Subject: FW: Georgian Woodlands Draft Plan Extension Deputation Materials (0196-5928)

MEMO

DATE November 1, 2024
RE Georgian Woodlands Sanitary Servicing**PROJECT NO.** 196-5928**TO** Brian Worsley, P. Eng., Manager of Development Engineering
FROM George Cooper, P. Eng. & Jon Proctor, P. Eng.
CC Alexander Fleming

This memorandum has been prepared in support of the proposed sanitary servicing strategy for the Georgian Woodlands Phase IV Stage 3 Residential Development. The second detailed design submission, prepared by C.F. Crozier and Associates (Crozier) dated January 26, 2024 proposed a low pressure sanitary forcemain with individual grinder pumps located within each of the 37 lots. Based on discussions with Town staff and the comments issued by the Town, dated June 3, 2024, we understand that the Town's preference for sanitary servicing would be via gravity sewer and sewage pumping station (SPS). Based on discussions with Town staff, our office is aware of the challenges the Town has encountered with low-pressure systems (LPS) in existing developments and the Town's concerns about expanding the use of these systems for future residential developments.

Drawing 110 – Interlaken Court Plan & Profile (STA 0+000 –
0+300)

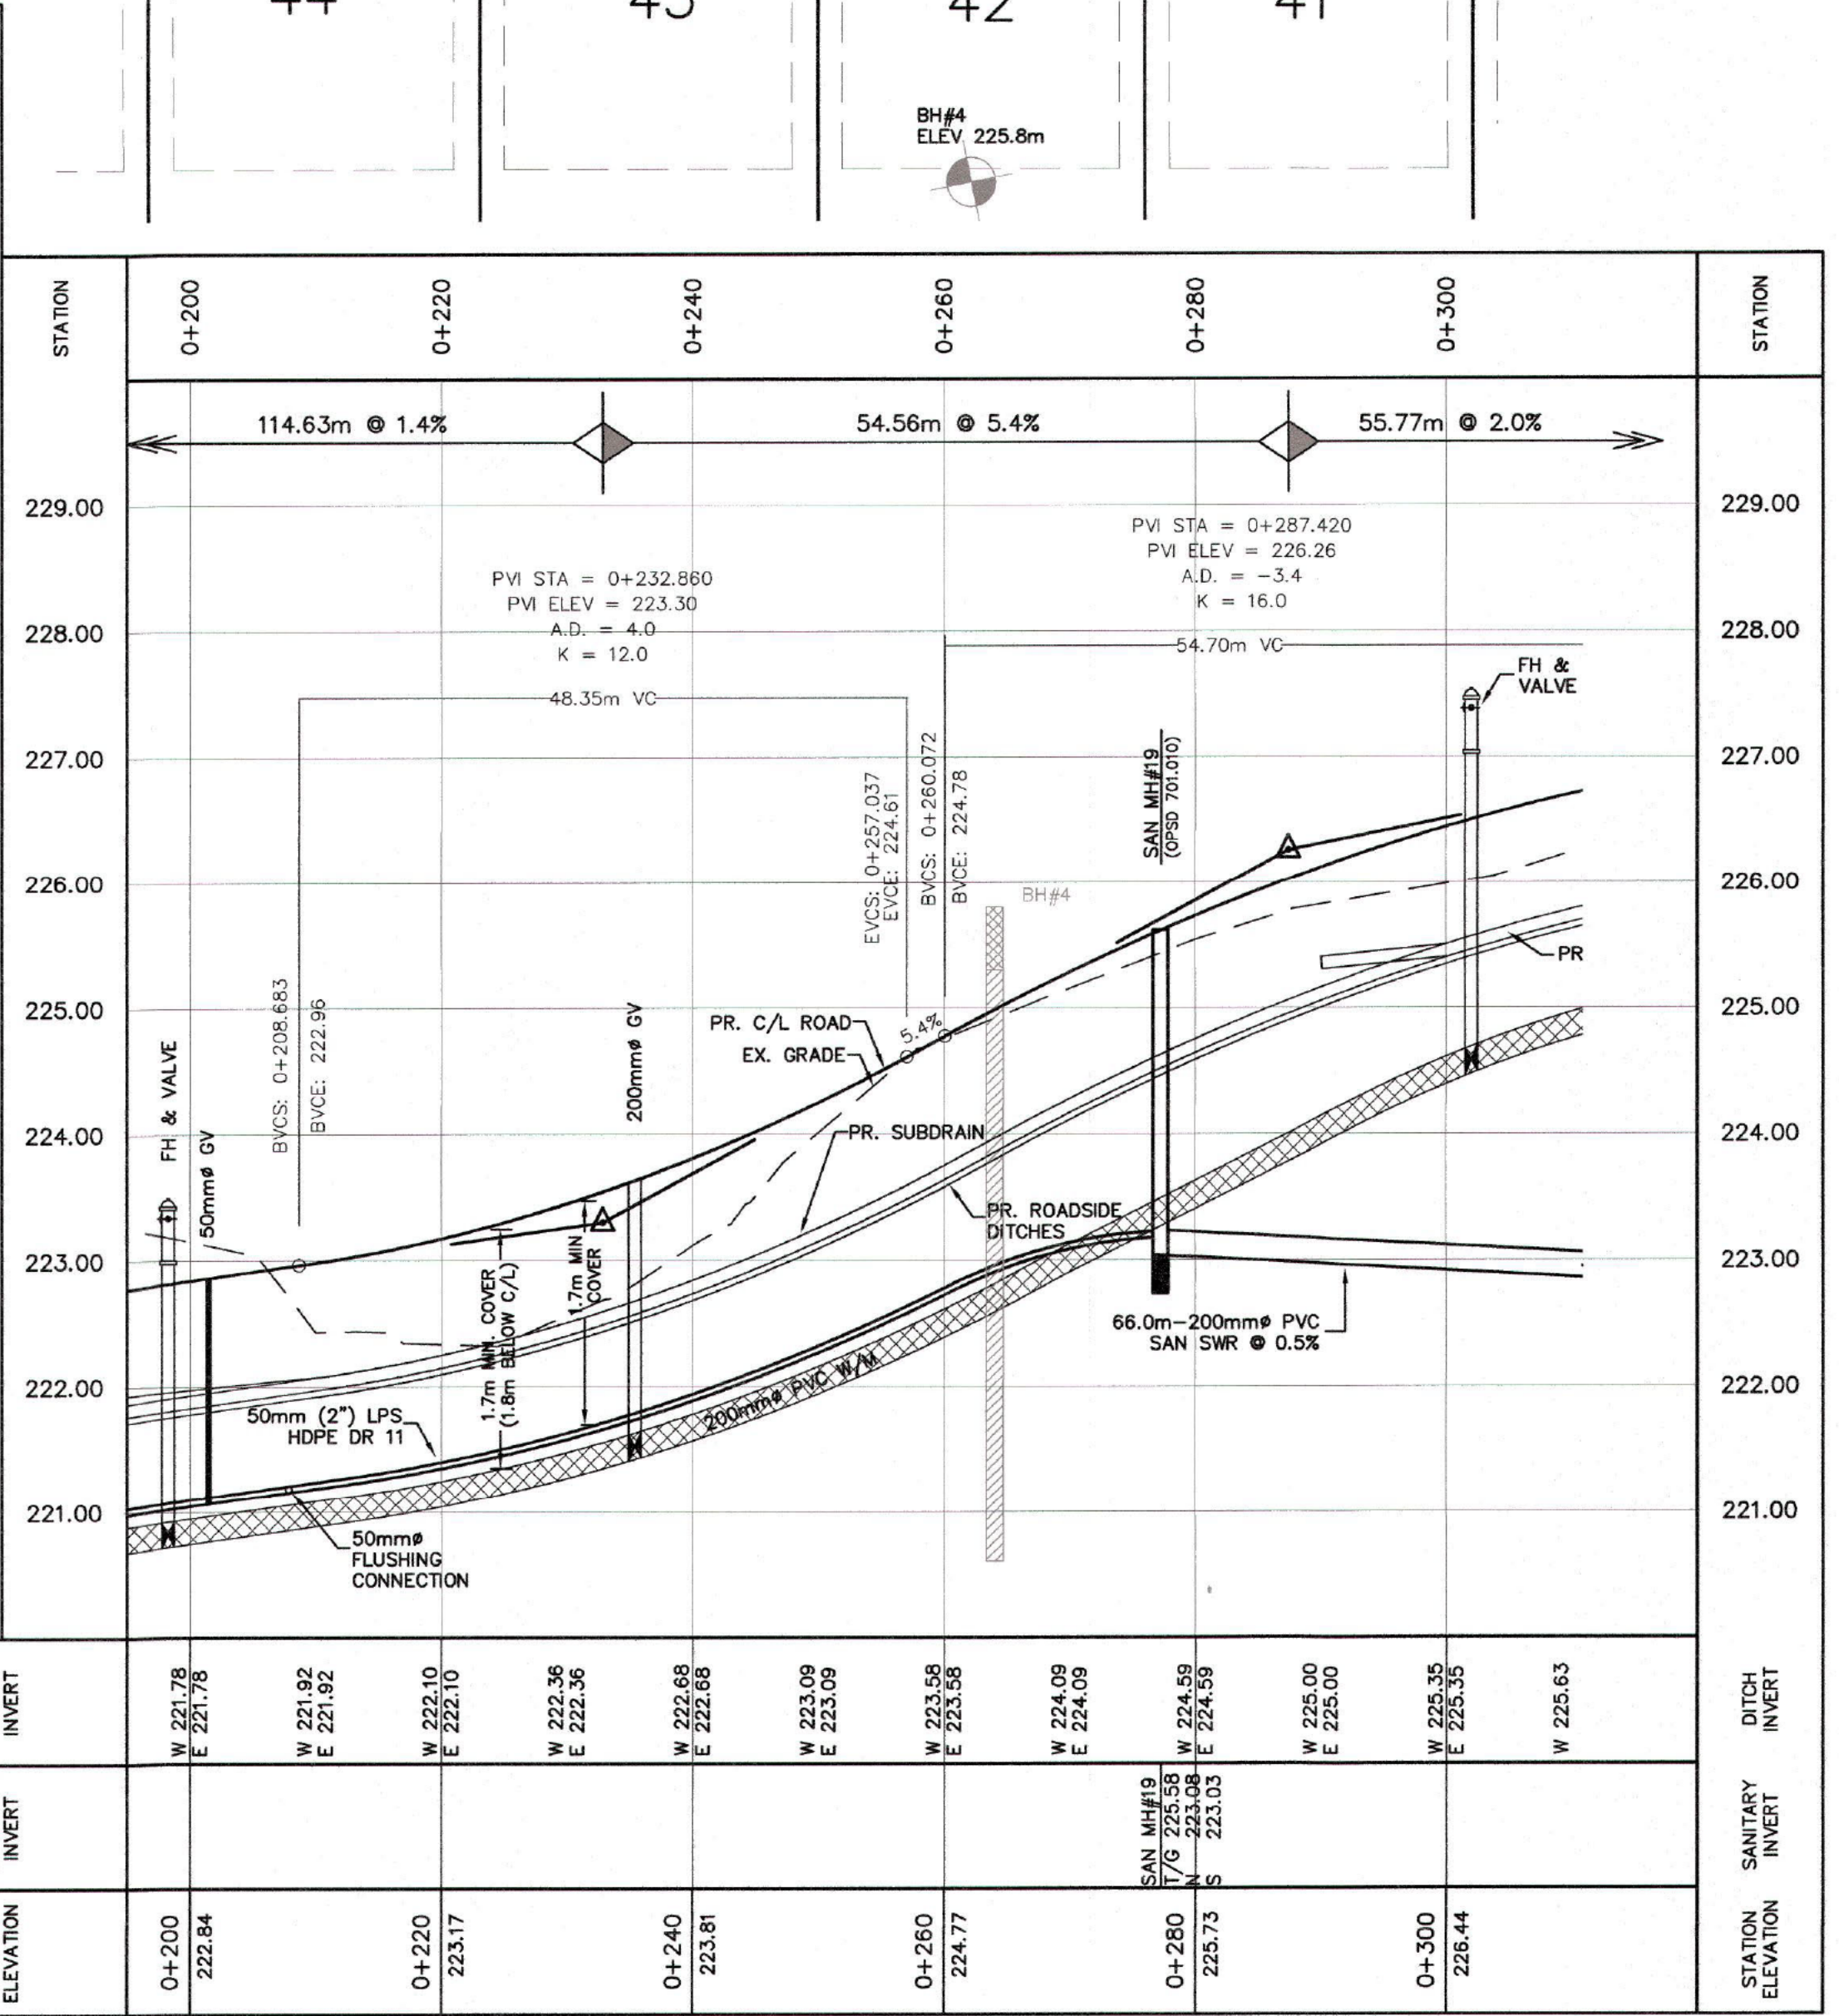
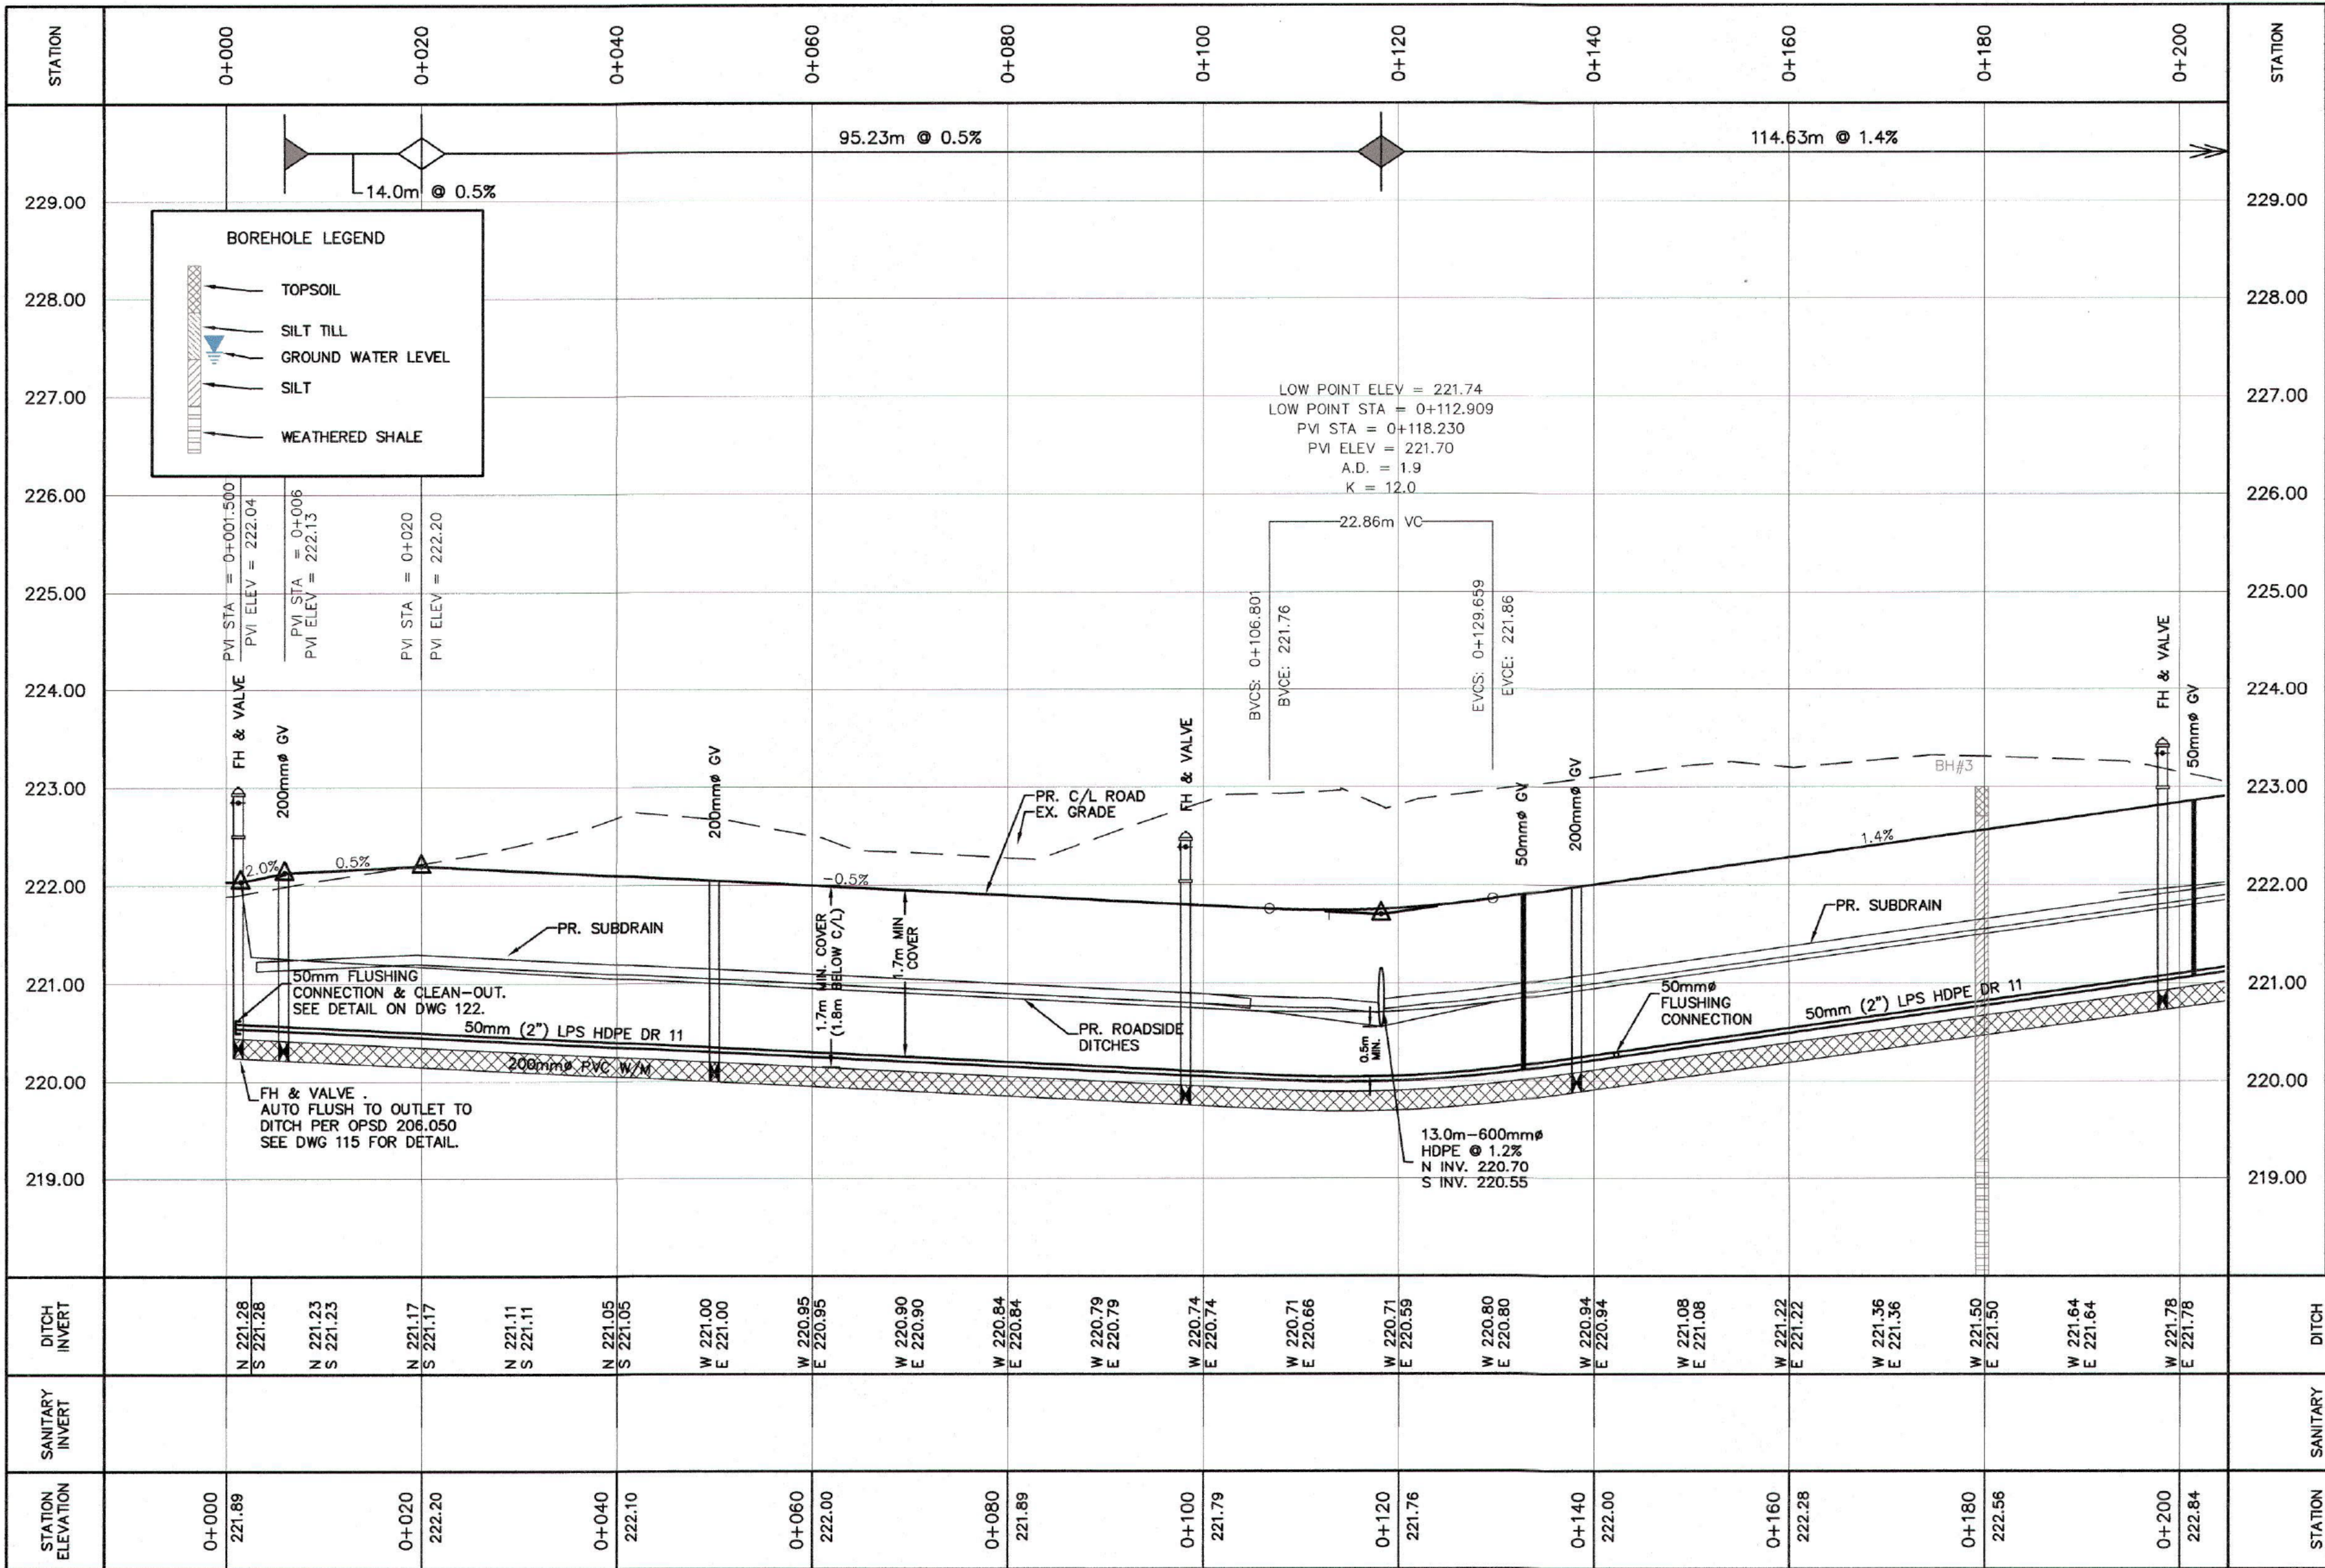
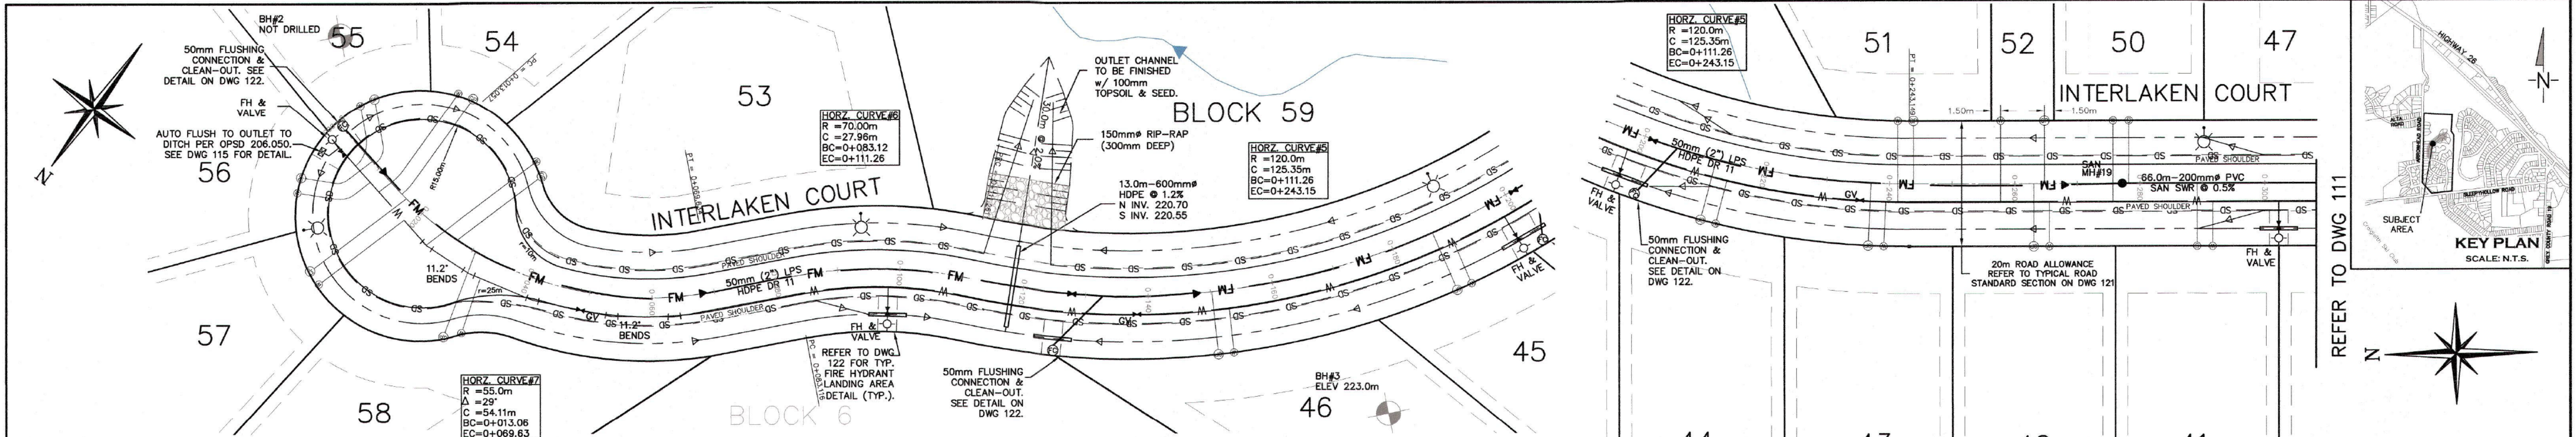
Draft Plan Approval was granted for the Plan of Subdivision of Georgian Woodlands Phase IV on June 8, 2010. The Draft Plan detailed a total of 249 units to be developed; 101 single-family residential lots and 148 multiple residential lots for future development. The 101 single-family residential lots, and associated infrastructure were to be completed in multiple stages. Stage 1 (5 lots) and Stage 2 (58 lots) have since been constructed and are now occupied. Of note, 13 units built in Stage 2 are serviced with a Low-Pressure System on Interlaken Court, as shown in the enclosed IFC drawing 110.
